**REQUEST FOR ADDITIONAL INFORMATION**  
**Environmental Planning and Assessment Regulation 2000 – Clause 54**

**Development Application No:** 1308/2021/DA-SL

**Property:** Lot 33 DP 700703, Lot 34 DP 700703, Julius Reserve, Julius Road,  
ROSEMEADOW NSW 2560, Lot 34 Julius Road, ROSEMEADOW

**Development:** Construction of a seniors housing development consisting of 45 self-contained dwellings and basement car parking

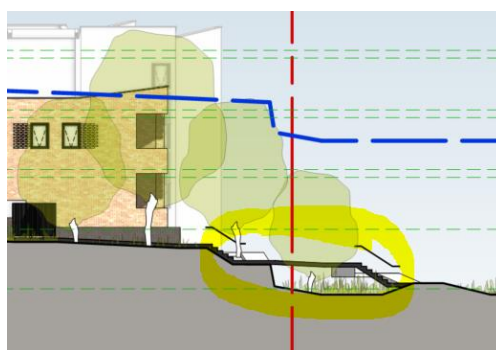
11. The driveway is required to be relocated or moved away from the subject pit, indicated below, outside of the vehicular swept paths. A minimum of 1m clearance is to be provided from the edge of the lintel to the edge of the wing of the driveway.

12. A revised landscaping plan is required and the planting species along the east boundary (within the drainage easement) are to be selected in accordance with Appendix H of Council's Engineering Design for Development.

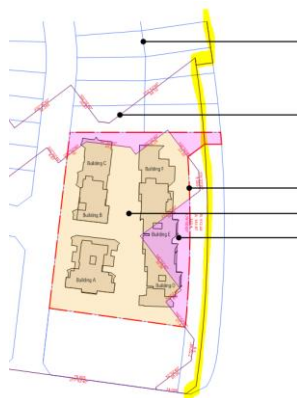
safely walk across roads to the relevant bus stops and through the Rosemeadow Market Place car park and submit the findings for review.
